From: Stephen Jones [REDACTED]
Sent: 06 June 2025 10:00
To: Stephen Jones
Subject: FW: 05533254 Jacktrees Road ,Cleator Moor, Moor Row, Cleator Moor, Cumberland, CA25 5NT

From: wastewaterdeveloperservices@uuplc.co.uk <wastewaterdeveloperservices@uuplc.co.uk>
Sent: 18 March 2025 10:12
To: Stephen Jones [REDACTED]
Subject: RE: 05533254 Jacktrees Road ,Cleator Moor, Moor Row, Cleator Moor, Cumberland, CA25 5NT

Photo No. 0928

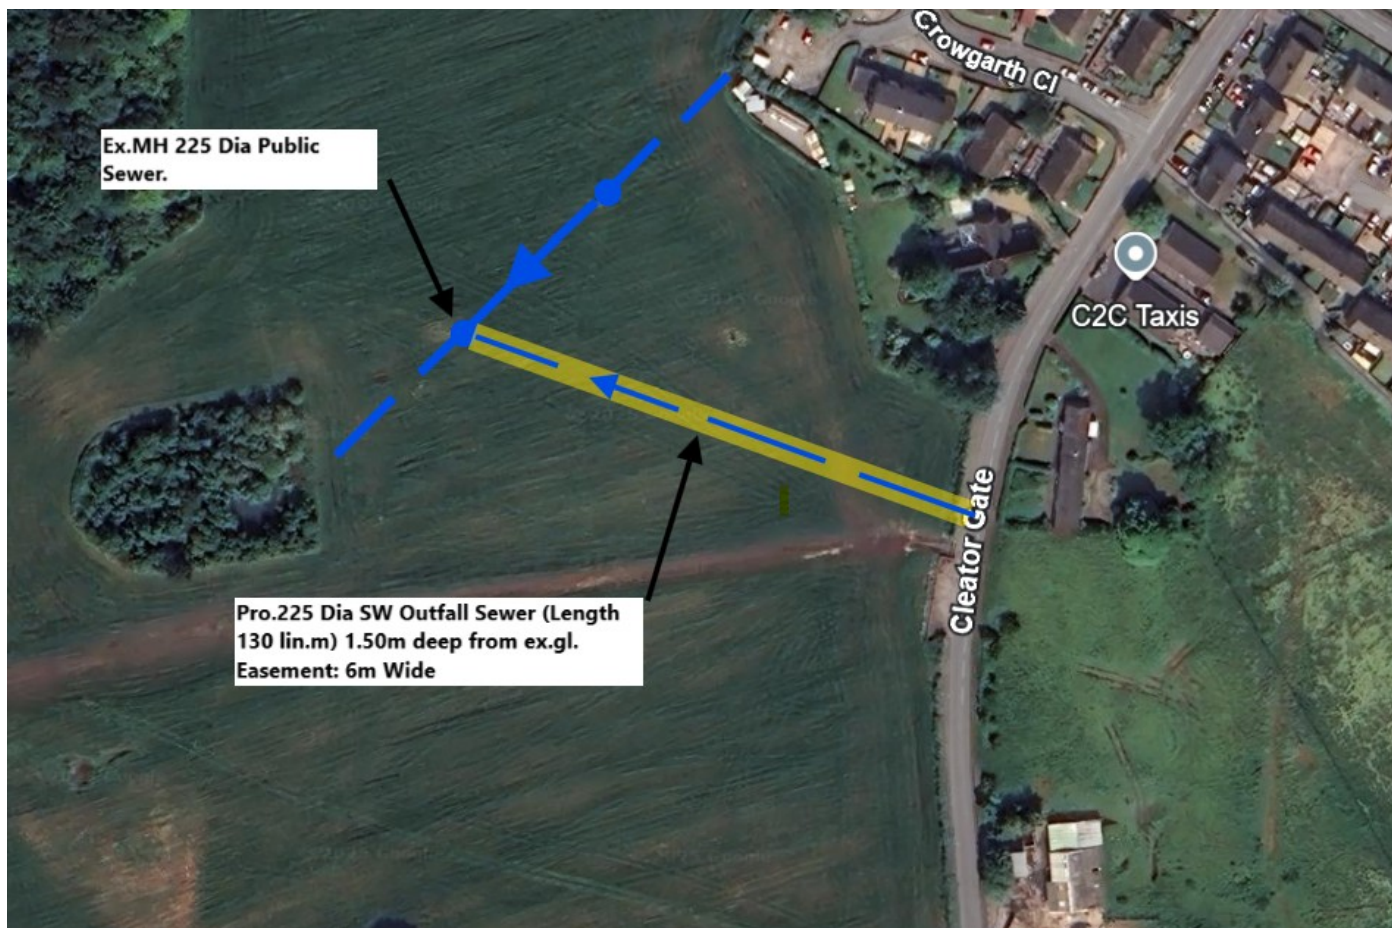
Please see screenshot showing the location and reference numbers of photos taken along the boundary/hedge line at the location of the water/ditchcourse you had identified. I will forward the photos under separate cover.

Photos 0928 & 0910 (see screenshot below) show the watercourse and the cover stone over the same to the location of the footpath. The watercourse can be best described as an overland route rather than a clearly defined ditchcourse suitable for discharging albeit restricted surface water flows from the housing development. Also, the watercourse is located on the farmland adjoining Donaldson Dairy's land, which we have had favourable discussions concerning an easement over their land (see screenshot below).

I would, therefore, propose the restricted surface water flows from the housing development (Phase 1 & 2) discharge by gravity sewer to the existing 225 Dia., gradient of 1/19 public sewer, which outfalls to the pond located within Donaldson Dairy's farmland. Please see attached Lidar survey (PDF) showing the topography of the Dairy's farmland, receiving Pond and ex. public sewer. Notably, there are 2 No manholes on the line of the public sewer located within the farmland that aren't shown on the sewer records.

As discussed, I am happy to confirm we will accept surface water flows to the 225mm public surface water sewer to the west of the site, subject to confirmation the discharge has onward flow to a recognised watercourse. Discharge rates must be restricted to the greenfield QBAR runoff rate which is 20.5 l/s (based on 2.1ha stated on the originally submitted enquiry form, using the IH124 method).

As discussed, a surface water pumping station is not required for this connection.

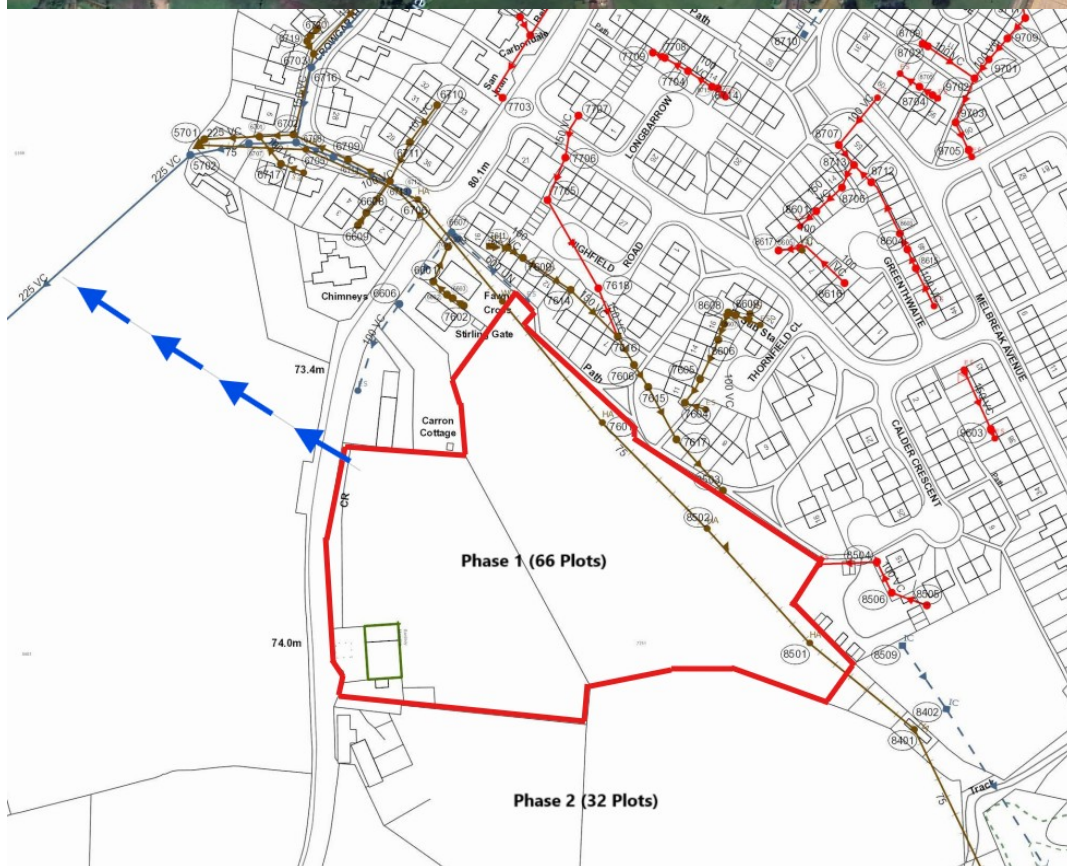
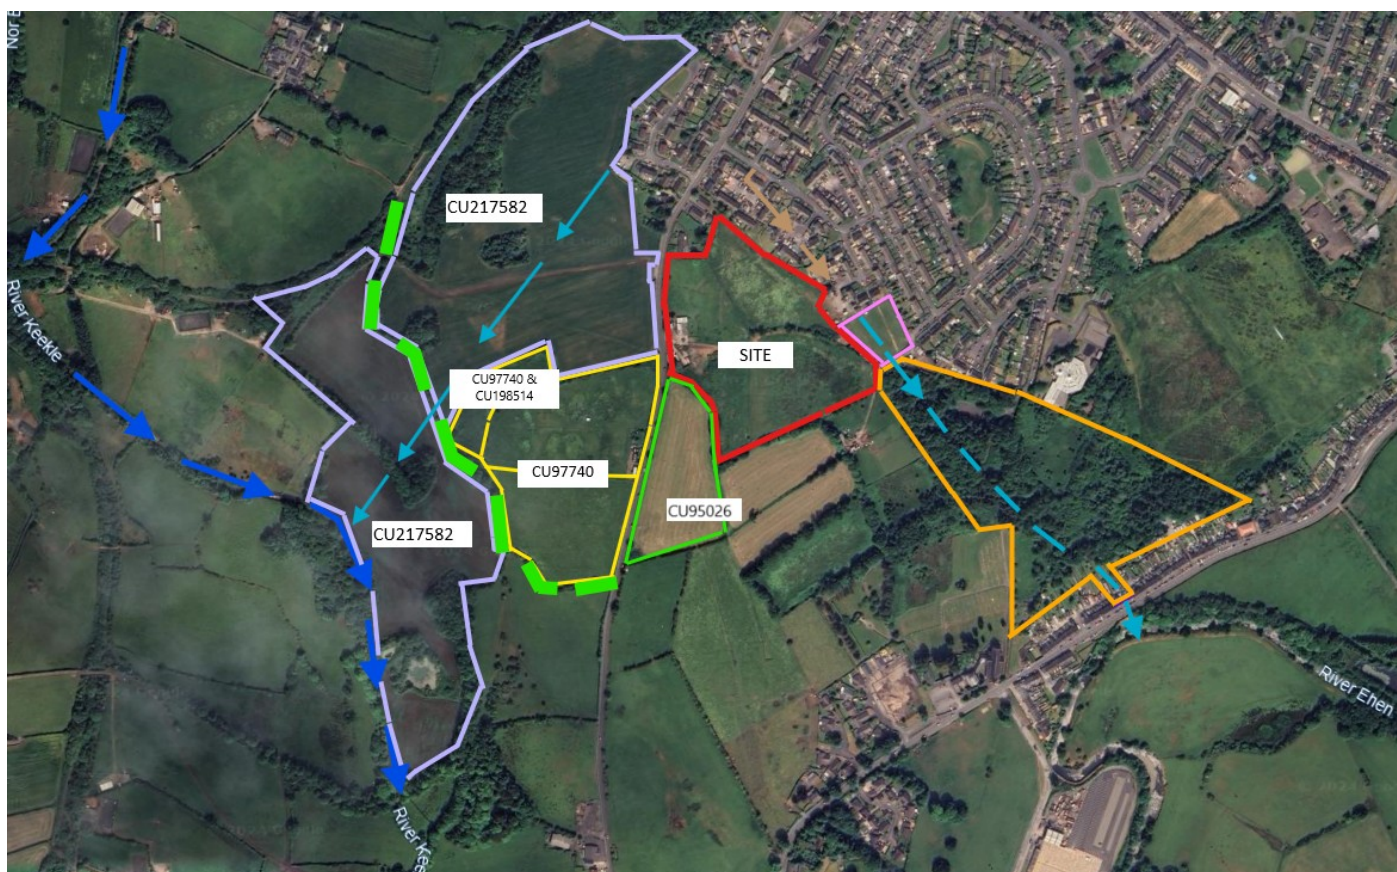
I have entered into discussions with the riparian owner of the parcels of land shown edged Purple (CU217582) and Yellow (CU97740) concerning obtaining their approval to construct the proposed surface water outfall sewer serving our development over their land to the R. Keekle.

I am having difficulty contacting the riparian owner of the land edged Green (CU95026) who no longer lives at the address registered on the 'Official copy of the register of title' for the land. We can't rule out the owner has passed away and there may be complication with the registered title of the land that could take a considerable time to resolve (see screenshot below & attached).

In view of the issues and difficulties we have faced to date with negotiating and obtaining the approval needed from the riparian owners to construct an outfall structure over their land I would like to put forward an alternative proposal for the surface water outfall to be lifted by way of a submersible pumping station to a POC located on the existing 275 Dia public sewer that is located within the land edged Purple (CU217582) and outfalls to the R. Keekle. (see screenshot below & attached).

I have had more favourable discussions with the riparian owner of the land edged Purple (CU217582) and believe I will obtain their approval to construct the surface water outfall to the POC located on the aforementioned existing 275 Dia. public sewer

Thank you for detailing the issues with obtaining landowner permissions. To reach a watercourse. I accept a solution which only includes crossing the land marked in purple in your email is required, i.e. I accept the land boundaries marked in green and yellow are unlikely to be possible to cross.

There does appear to be a watercourse on the boundary between the purple and yellow areas, so a watercourse system of some kind may well be reachable without crossing the yellow or green boundaries. I have circled this red in the attached snippet. This is likely where the flows from our surface water sewer (which is mapped to outfall to natural ponds just north) will end up. So another option may be to discharge directly to the same natural ponds that our existing sewer discharges to. These options would need to be explored further, but ultimately if these are explored and properly discounted then I would be willing to accept a connection to public 225mm surface water sewer.

I would also comment that the topo lines suggest it is roughly downhill to this area from the site, so I would not envisage a pumping station being required. We would require detailed justification/evidence proving a pumping station is required before we would consider adopting one (whether the outfall ends up being to watercourse or to the public surface water sewer).
